ESP32 ECO V3

User Guide

This document describes differences between V3 and previous ESP32 silicon wafer revisions.

3. Label Specification

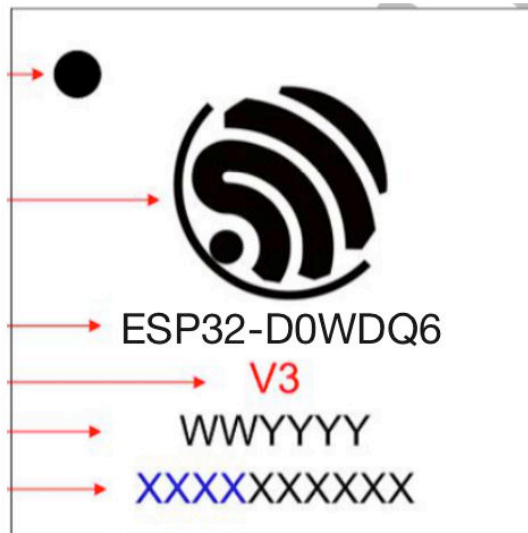
The label of ESP32-D0WD-V3 is shown below:
